PRODUCT/PROCESS CHANGE NOTICE (PCN)

PCN #: TB1303-01 DATE: April 1, 2013 Product Affected: TQFP-32, TQFP-48 shipped in Tape & Reel (Refer to Attachment II for affected part#) Date Effective: July 1, 2013	MEANS OF DISTINGUISHING CHANGED DEVICES: <input type="checkbox"/> Product Mark <input type="checkbox"/> Back Mark <input type="checkbox"/> Date Code Shipment starting from July 1, 2013. <input checked="" type="checkbox"/> Other
---	---

ATTACHMENT I - PCN #: TB1303-01

Detail of Change: This notification is to advise our customers that IDT has qualified a new revision of a carrier tape for packages TQFP-32 and TQFP-48.

Figure1: Illustration on Existing Carrier Tape and New Carrier Tape

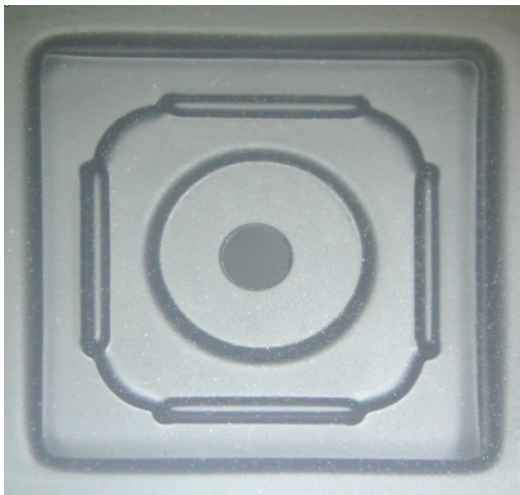
The new carrier tape has changes in pocket dimensions and design that enhances pick and place function during board mount process. The new carrier tape is designed with increased pocket depth from 1.3mm to 1.55mm, which will avoid unit protruded above the top surface of the carrier tape.

TOLERANCES UNLESS OTHERWISE SPECIFIED		ANGLE ±.5°	
DECIMAL	X ± .25		
.XX ± .13			
.XXX ± .13			
APPROVALS	DATE	WWW.IDT.COM	
DRAWN		TITLE: ES/ESG 48 & PR/PRG 32/48 CARRIER TAPE (PCT)	
STOCK NO. P8-159-P32		DRAWING NO. MSC-3378	
DO NOT SCALE DRAWING		REV 03	
		SCALE N/A	
		SIZE	
		REV	
		SHEET 1 OF 2

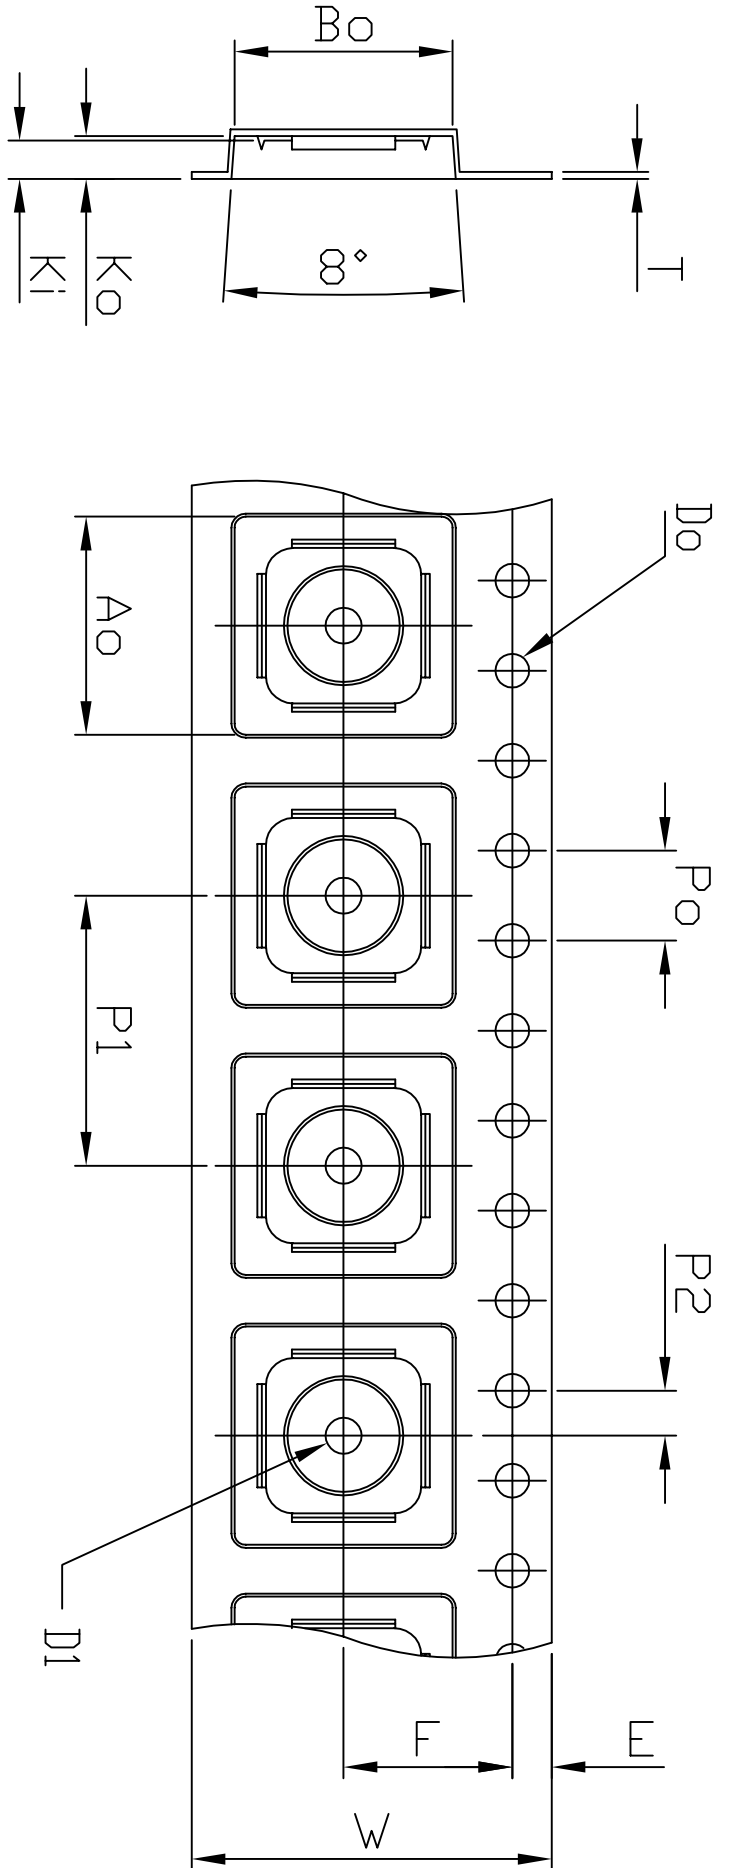
Refer to Table 2 for the comparison of the existing and new carrier tape.

Description	Existing Carrier Tape (part#: P8-159-P32)	New Carrier Tape (part#: P8-422-000)
Pocket Width, Ao (mm)	9.8 ± 0.1	9.5 ± 0.1
Pocket Length, Bo (mm)	9.8 ± 0.1	9.5 ± 0.1
Pocket Depth, Ki (mm)	1.3 ± 0.1	1.55 ± 0.10
Pocket Pitch, P1 (mm)	12.0 ± 0.1	12.0 ± 0.1
Total Pocket Depth, Ko (mm)	1.8 ± 0.1	2.0 ± 0.1
Carrier Tape Width, W (mm)	16.0 ± 0.3	16.0 ± 0.3
Carrier Tape Thickness, T (mm)	0.30 ± 0.05	0.30 ± 0.05
